## CITY of NOVI CITY COUNCIL

Agenda Item 1  
March 23, 2015

**SUBJECT:** Consideration of the request of GR Meadowbrook LLC for consideration of a Special Development Option Concept Plan. The subject property is 26.62 acres in Section 23 of the City of Novi and located on the south side of Grand River Avenue, west of Meadowbrook Road in the GE, Gateway East District. The applicant is proposing a 210 unit multiple-family gated community.

A public hearing for the request was held by the Planning Commission on February 25, 2015. At that meeting, the Planning Commission recommended approval of the Huntley Manor Special Development Option Concept Plan JSP 14-56. Relevant minutes from the Planning Commission meeting are attached.

HEET NUMBER  
 A6

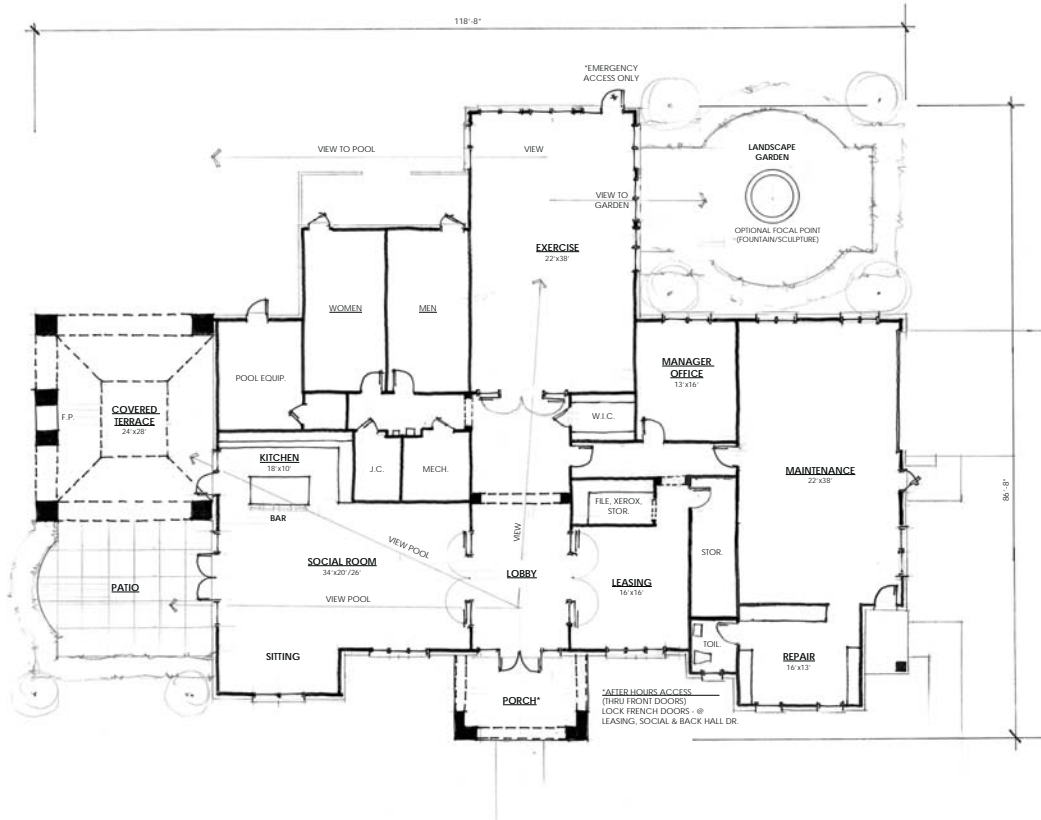
<b>Clubhouse (Sheet A-6)</b>	Front	Rear	Right Side	Left Side	Ordinance Maximum (Minimum)
Brick	20%	30%	30%	30%	100% (30% Min)
Stone	15%	10%	0%	15%	100%
Shake Siding	5%	10%	0%	0%	50% (Note 11)
Horizontal Siding	10%	5%	15%	15%	50% (Note 11)
Asphalt Shingles	<b>40%</b>	<b>35%</b>	<b>35%</b>	<b>30%</b>	25%
Wood Trim, Columns, etc.	10%	10%	20%	10%	15%
